ADDENDUM NO. 2

DATE: June 5, 2020
FROM: City of Grand Junction Purchasing Division
TO: All Interested Parties
RE: Avalon Theatre Marquee RFP-4795-20-SH

1 EAST ELEVATION
1/8" = 1'-0"

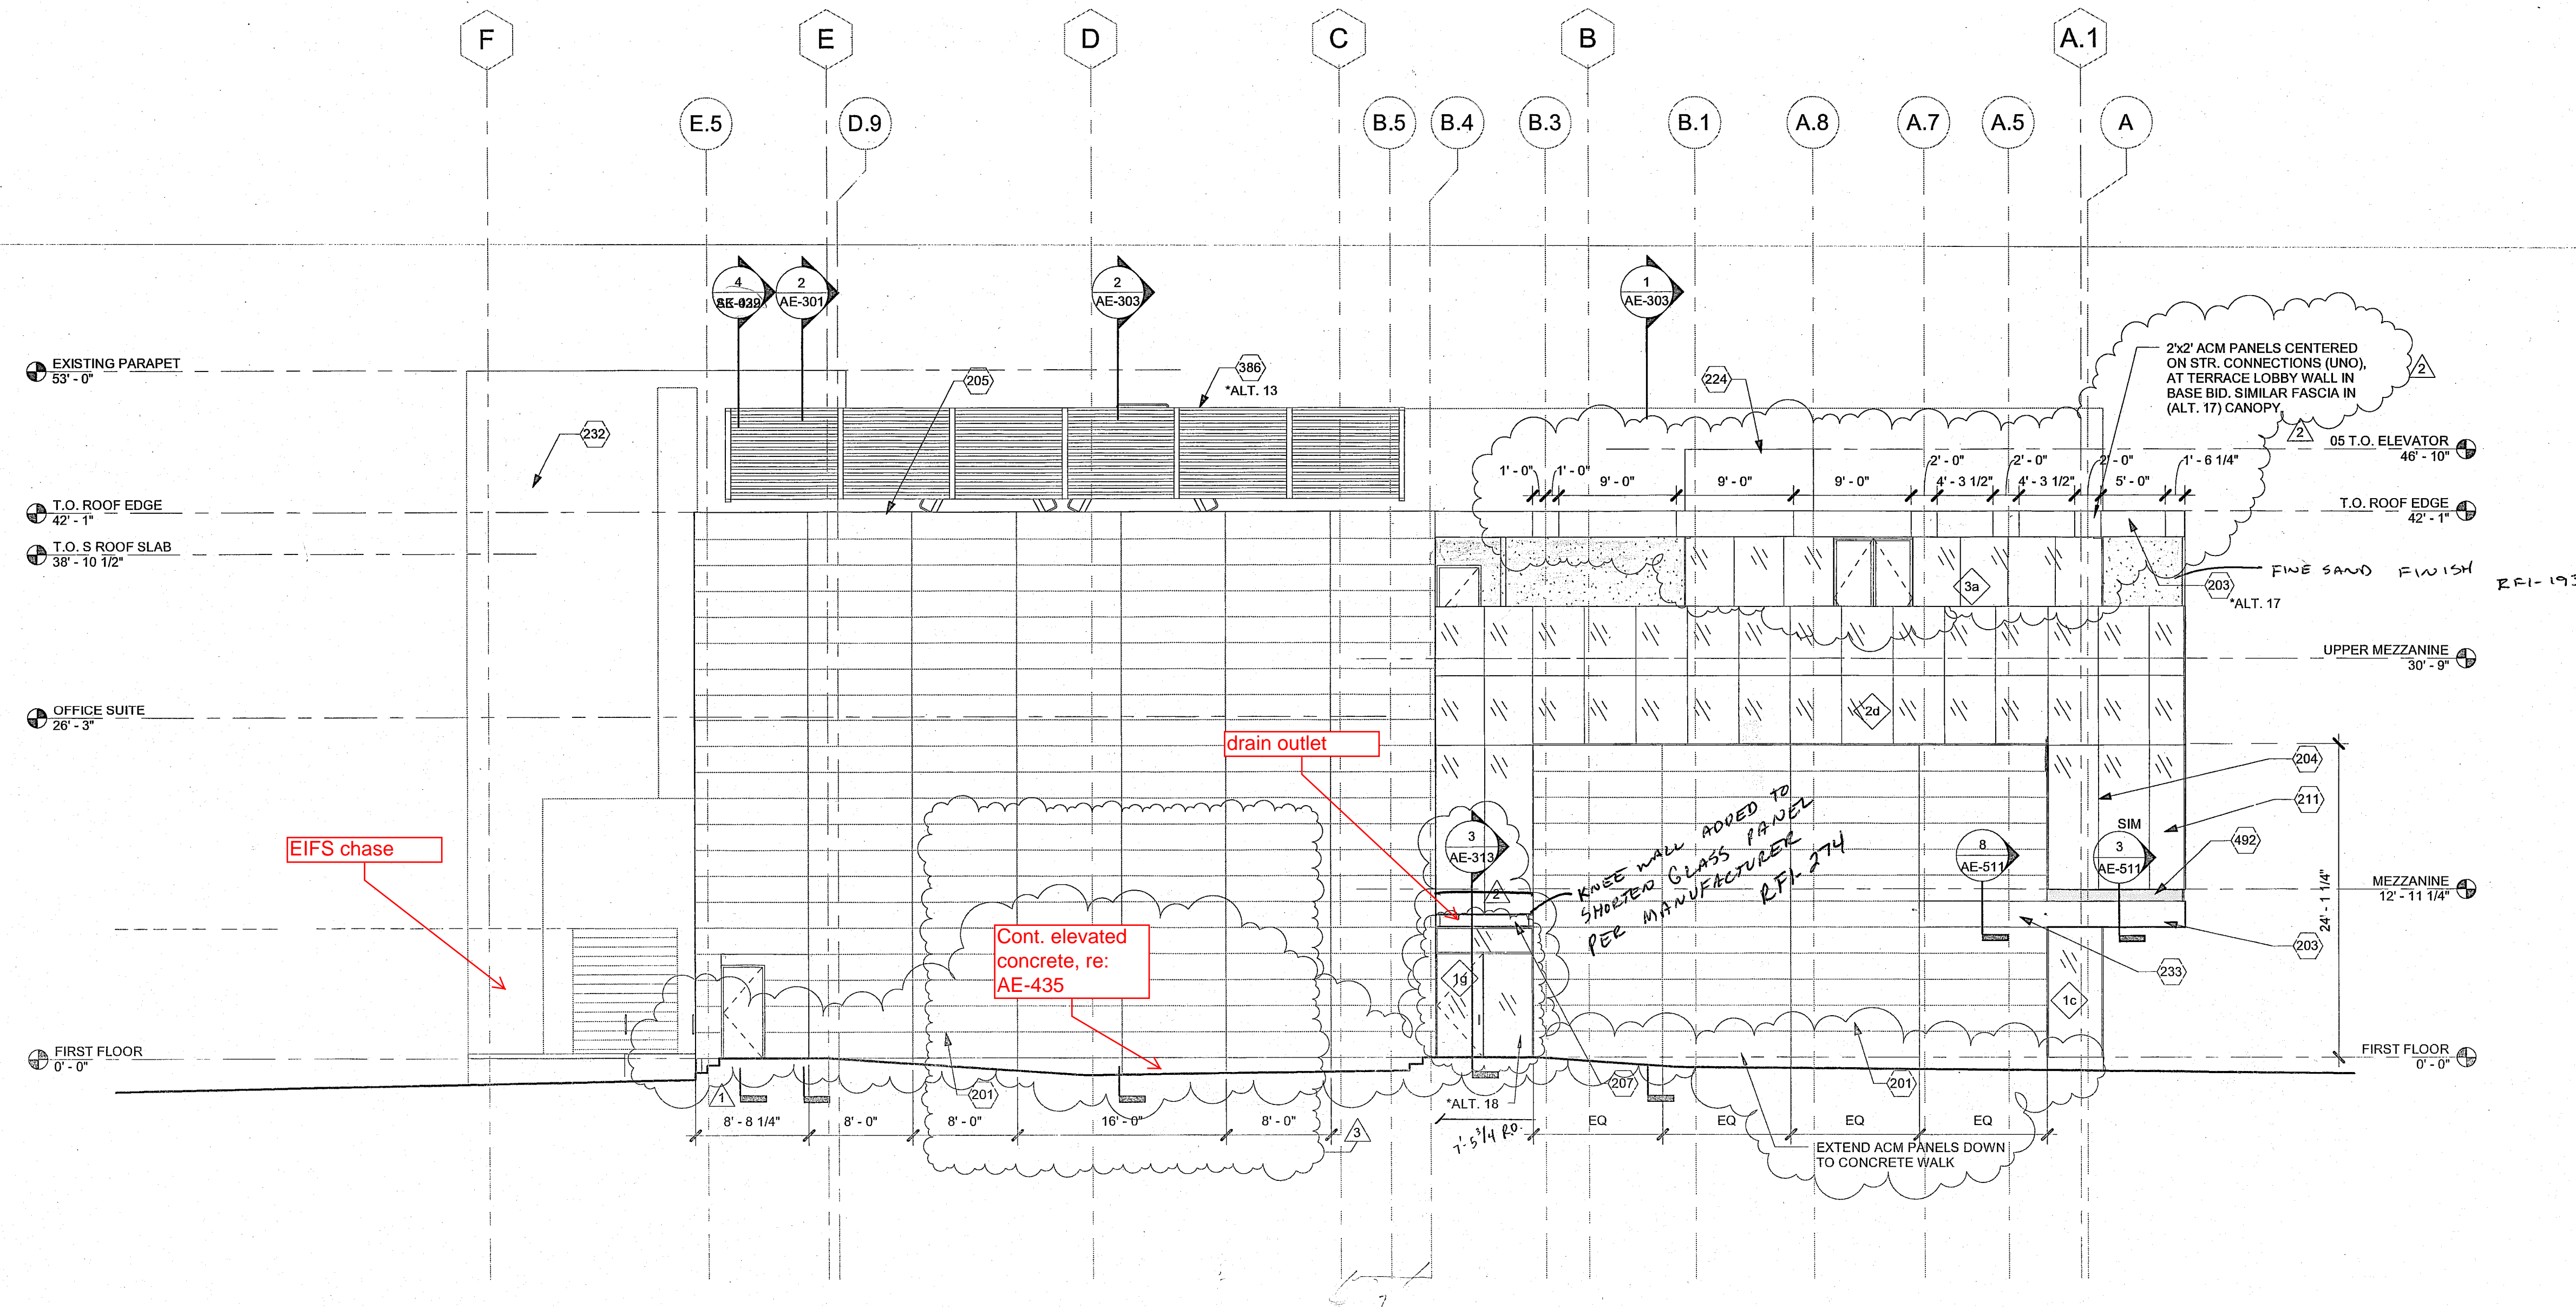
9. **Question:** What is behind the fascia of the East and North sides of the theatre? I am concerned with what structure is available for anchoring the signage.

13. **Question:** Are there dimensions available for each side of the sign?

14. **Question:** What is the material that we will be attaching the display to? I.E. Concrete Panel, composite material?

Answer: Please see the Attachments included in this Addendum.

Answer: Please see the Attachments included in this Addendum

Answer: Please see the Attachments included in this Addendum

Sheet AE-201 (East & West Elevations)
Sheet AE-202 (North & South Elevations)
Sheet AE-312 (Wall Sections – see #4)
Sheet AE-313 (Wall Sections – see #4/313)
